Complaint - B-Pillar Trim Panel (Lower Part) Sticking Up: Reworking Main Wire Harness in Passenger Compartment (110/20)

Model Line: **Taycan (Y1A)**

Model Year: **2020**

Subject: **B-pillar trim panel (lower part)**

Lower part of B-pillar trim panel

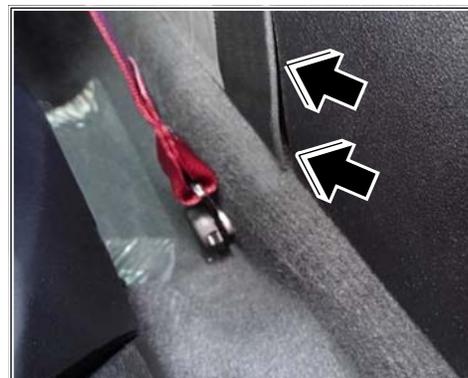
Information: The main wire harness in the passenger compartment is not secured and as a result, it can press against the lower part of the B-pillar trim panel and loosen it ⇒ *Lower part of B-pillar trim panel.*

Remedial Action: Secure main wire harness in passenger compartment at the left and right using tie-wraps.
